RE: Response to Comments, Bennoc Area NPDES OIL00159 Application for American Energy Corporation in Belmont County, Ohio

Response to OEPA Comments from Bruce Goff and Eric Nygaard Dated 8/21/12, 8/15/12, 7/20/12, 7/13/12, and 7/11/12 Bennoc NPDES Permit Application OIL00159

Hydro-Chemical Analysis of Waste Water Discharge and Anti-Degradation Assessment: American Energy Corporation's Bennoc Coarse Coal Refuse Area Ponds 001 and 002

Unnamed tributary 23 downstream view of physical habitat

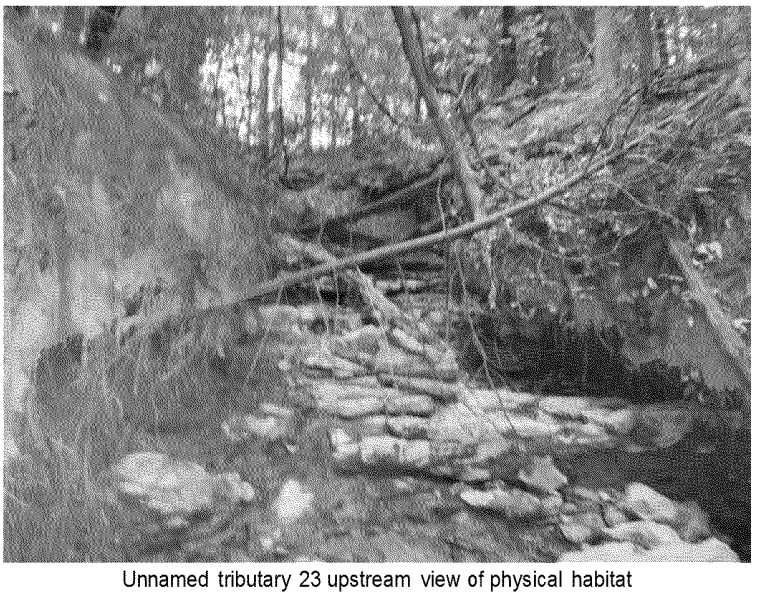
Comment: I don't know if would be on any use to us to help with permitting, but if you can have your biologists look at the two small tribs that both ponds discharge into and evaluate their potential for aquatic life use, that may be helpful.

Response: A field investigation was completed on July 13, 2012. The results of this investigation can be found in the attached report, "Investigation of Unnamed Receiving Tributaries to Piney Creek."
